## KARACHI MUNICIPALITY.

MEMO:—

With reference to <sup>his</sup>~~their~~ application dated 24/6/26 with aplan for the proposal Building additional on plot No. 104 Survey Sheet No. 87.

With reference to <sup>his</sup> ~~their~~ application dated.....13-11-26.....with aplan for the proposed <sup>Building</sup> ~~addition~~ on plot No. 104 Survey Sheet No. 27

### SECOND FLOOR PLAN

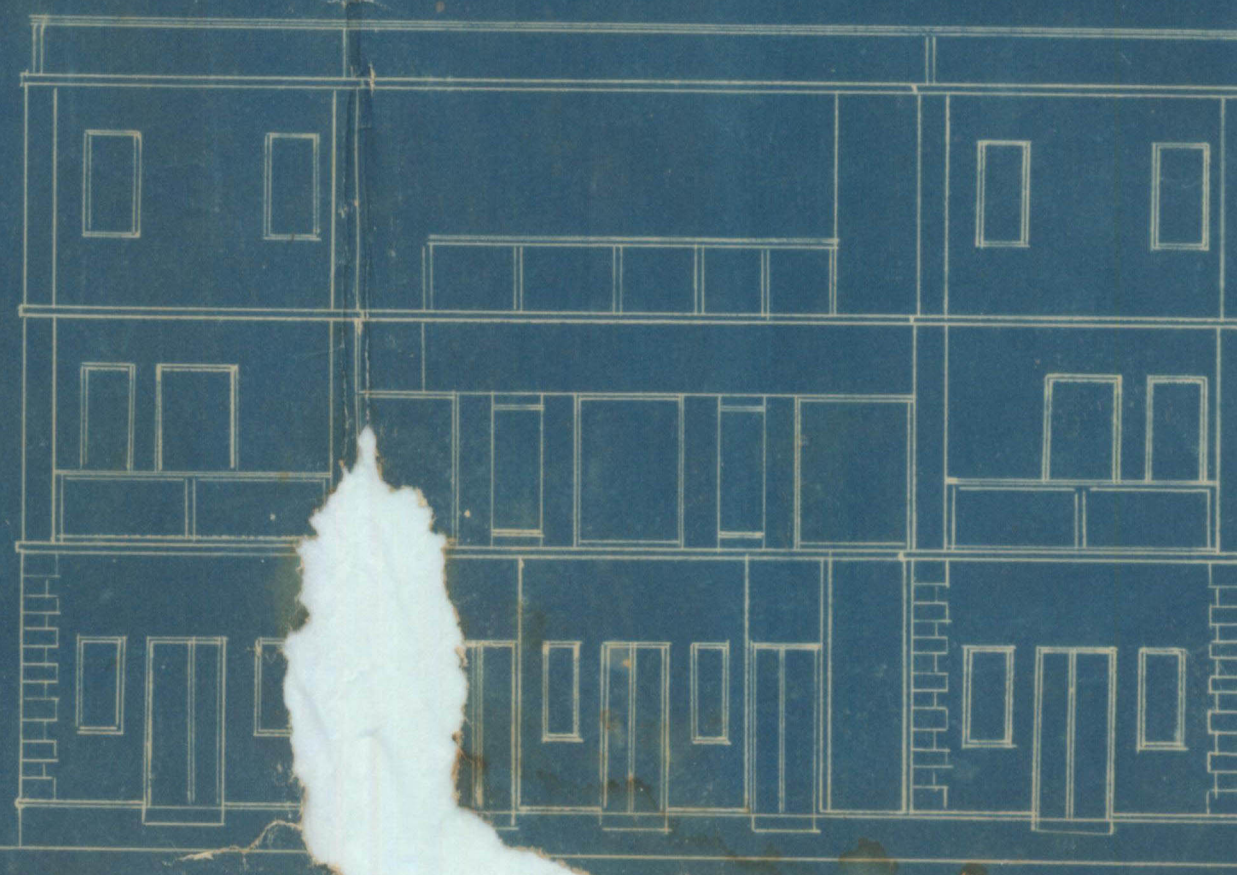
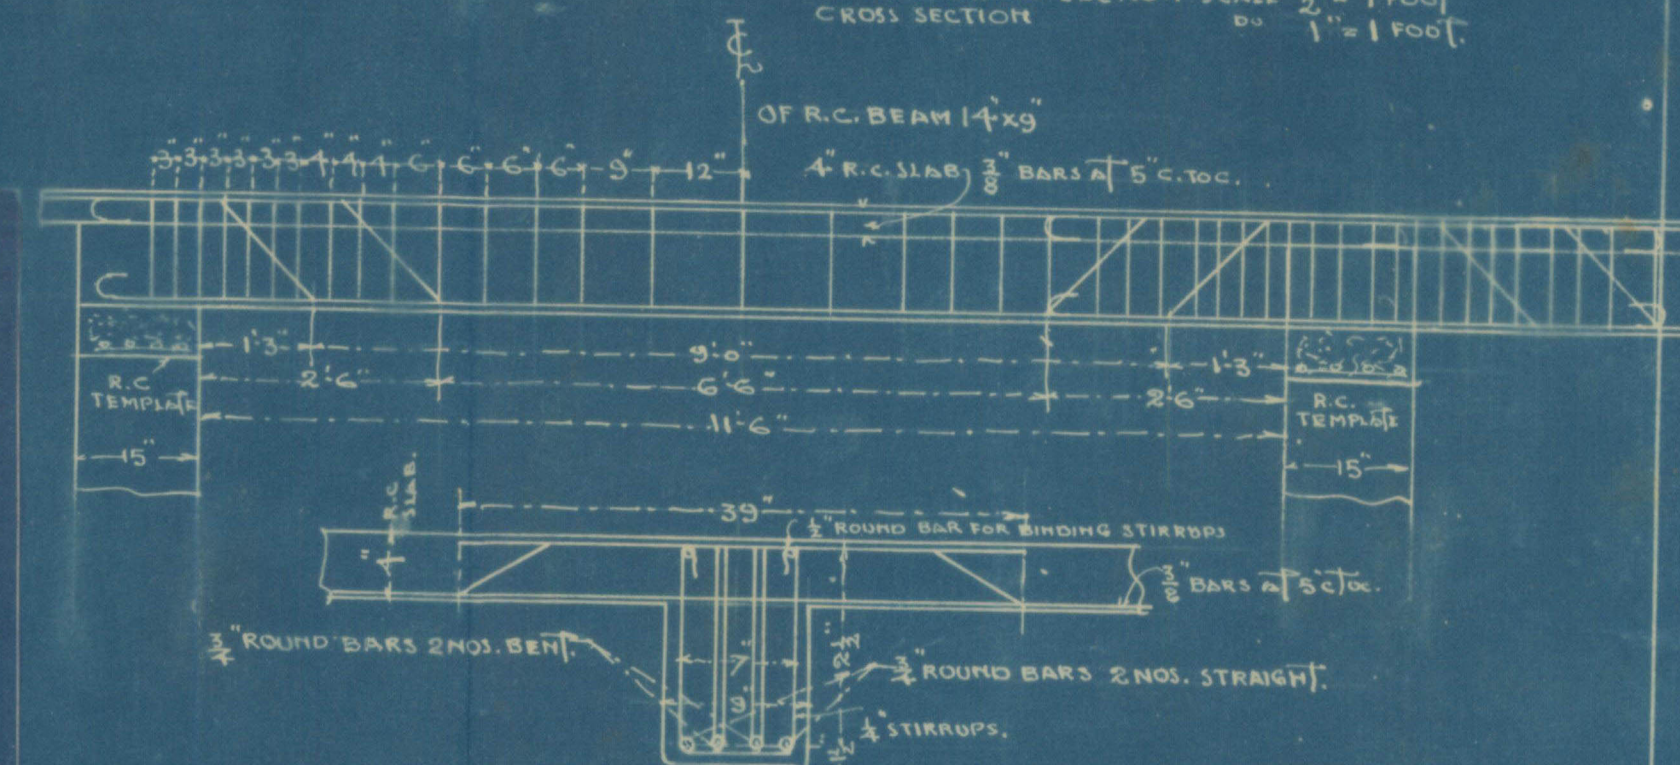
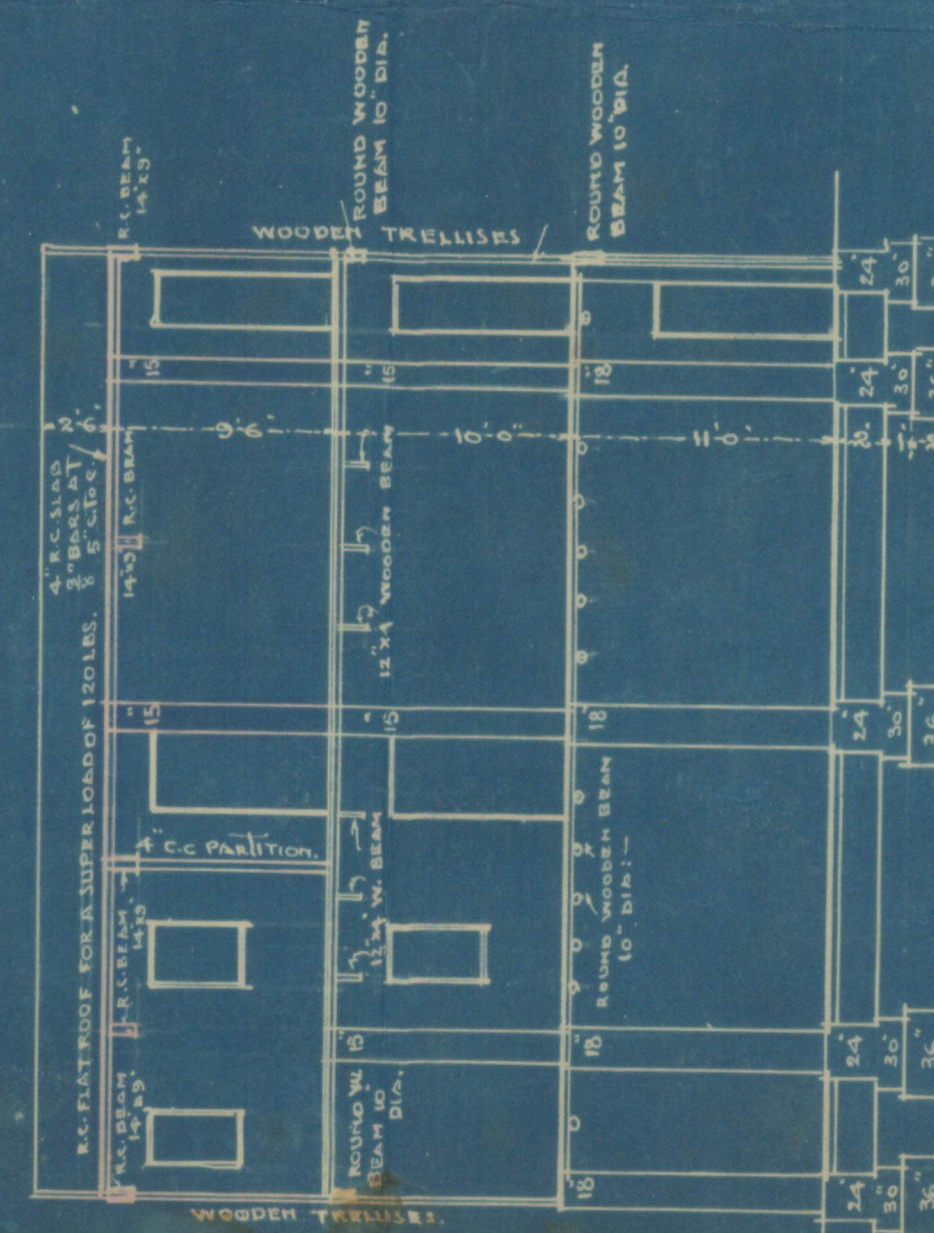
(1) Kitchens must be provided.

✓ (2) R.C. Beam & slab reinforcement must <sup>be</sup> shown on Section; and Calculations for R.C. Beams & Slabs should be submitted.

✓ (3) W.C. &amp; Sink having window heads communicating with rooms can not be permitted.

(4) Corridors for such a chawl ought to be at least 6 ft.

✓ (5) Nature of Partitions wall should be shown.

(7) Party walls can not be permitted.

✓ (8) The thickness of Main walls on first floor should be 16½".

✓ (10) Drossmers must be shown on plan

✓ (11) Position of section must be marked on plan

✓ (12) Nature of lintels must be specified.

SITE PLAN  
SCALE 40' = 1 INCH.

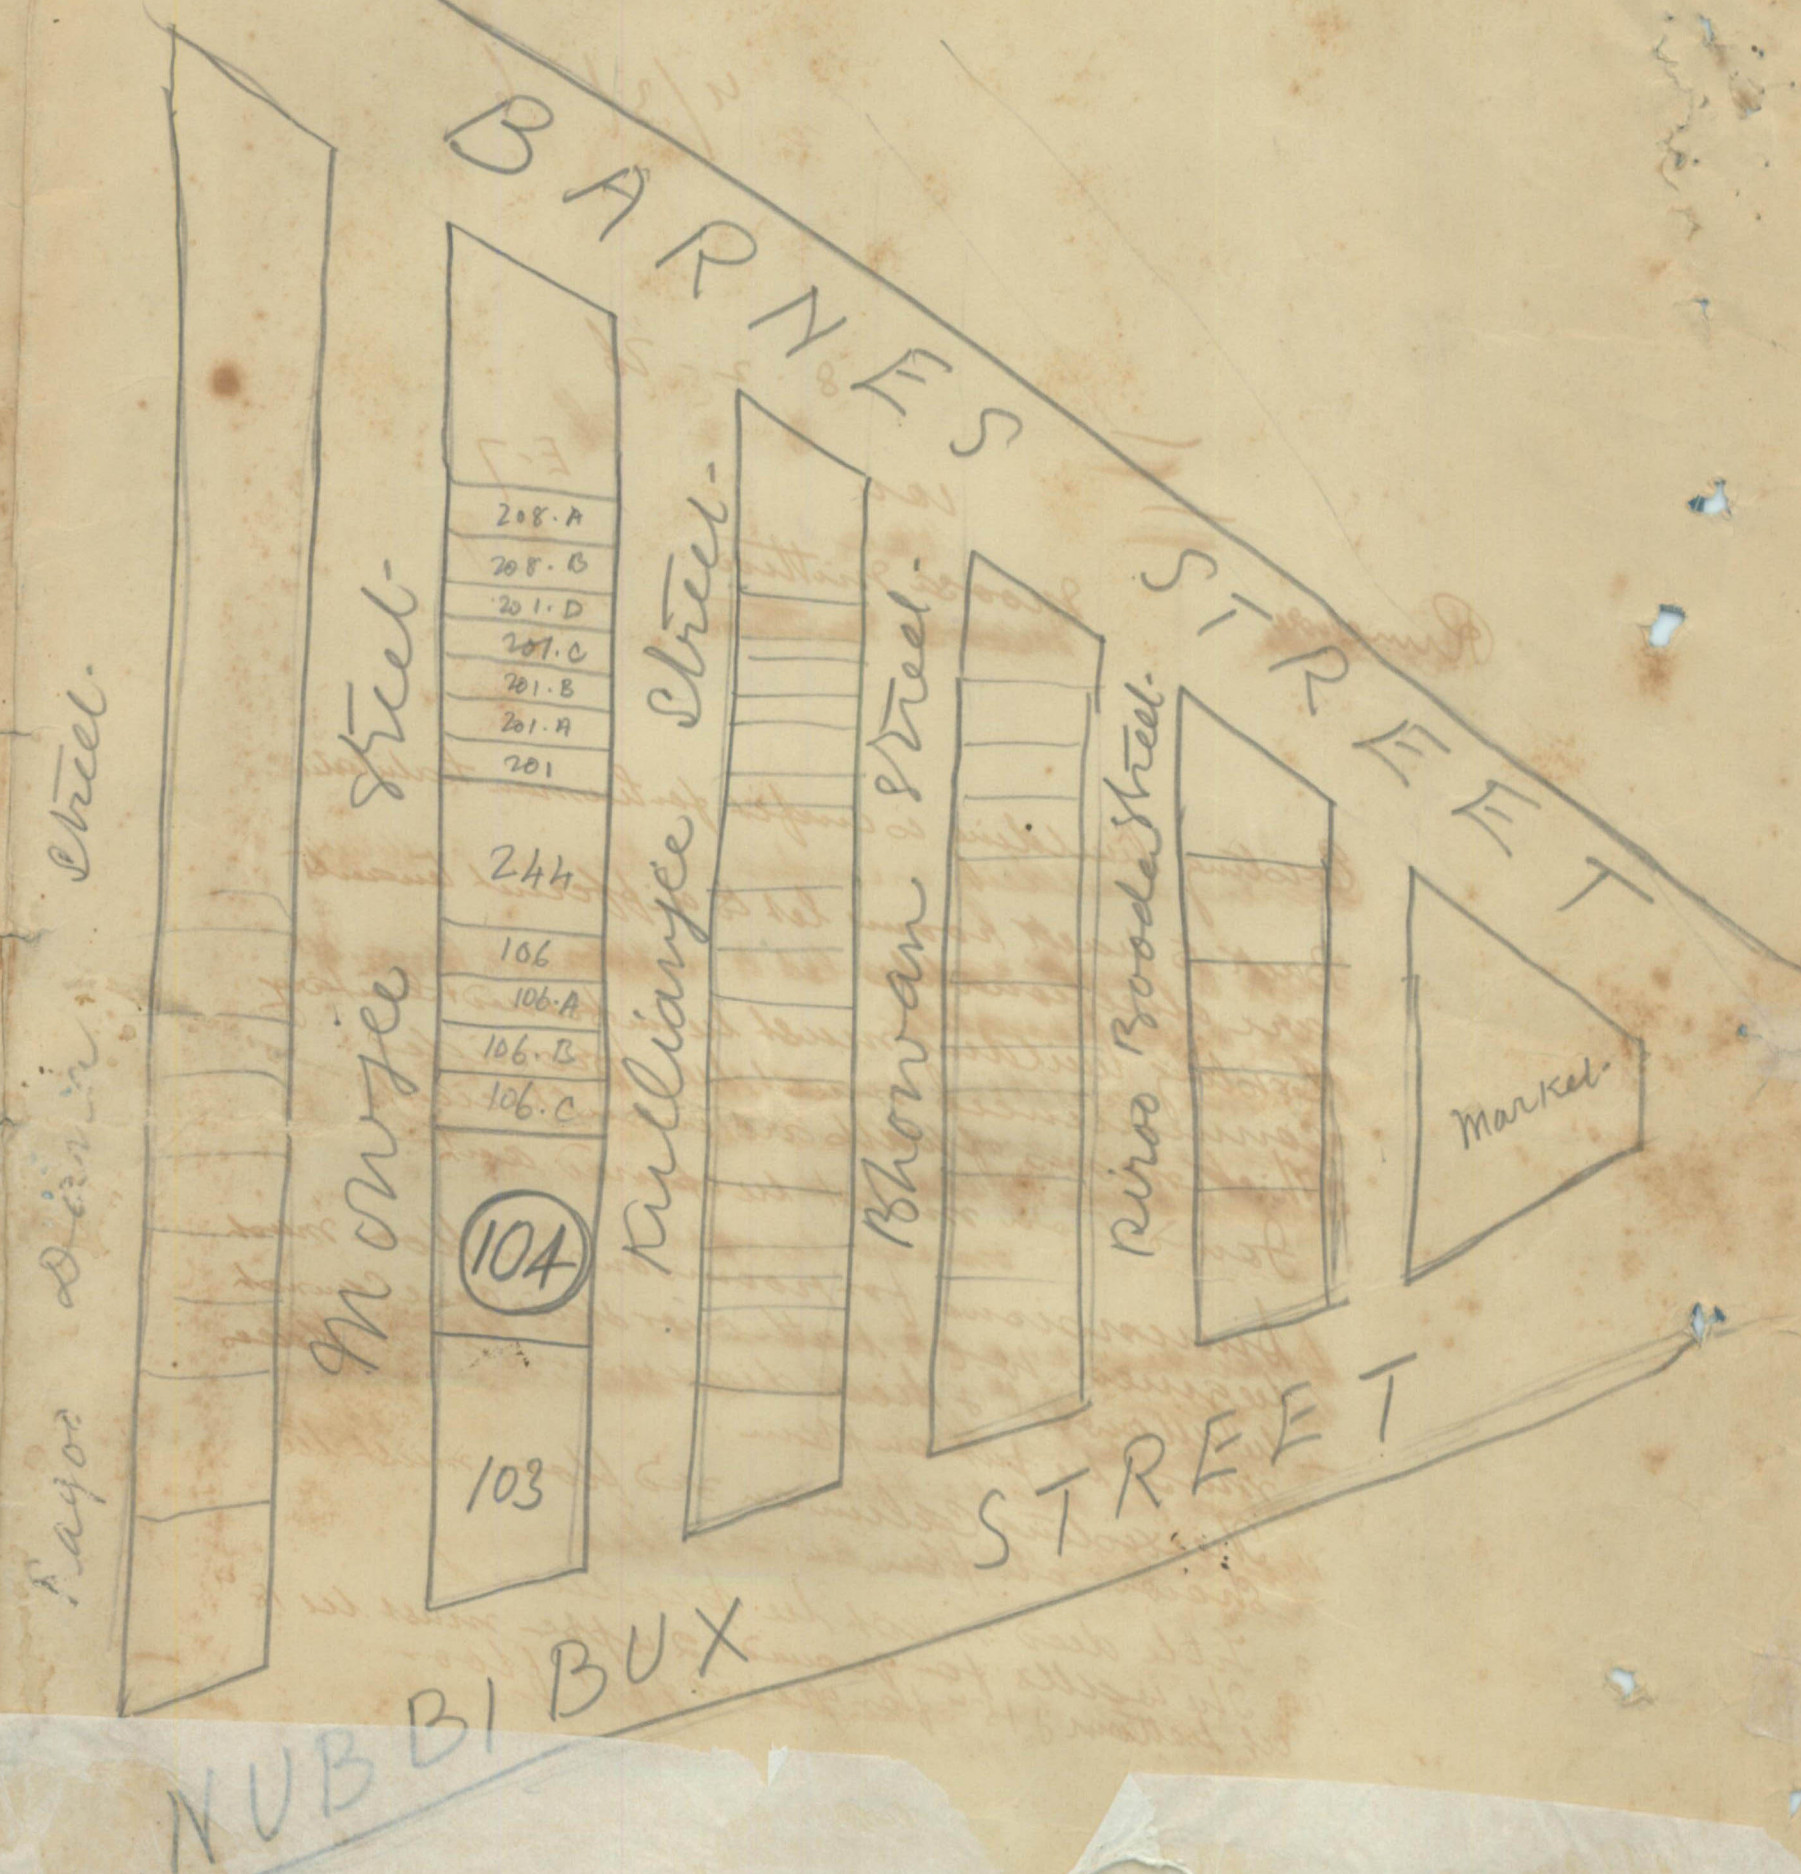
✓ (6) Width of Streets, heights of adjoining buildings and their plot nos. must be shown on site plan.

4. Width of streets, heights of adjoining structures  
& their plot nos: must be shown on site plan.
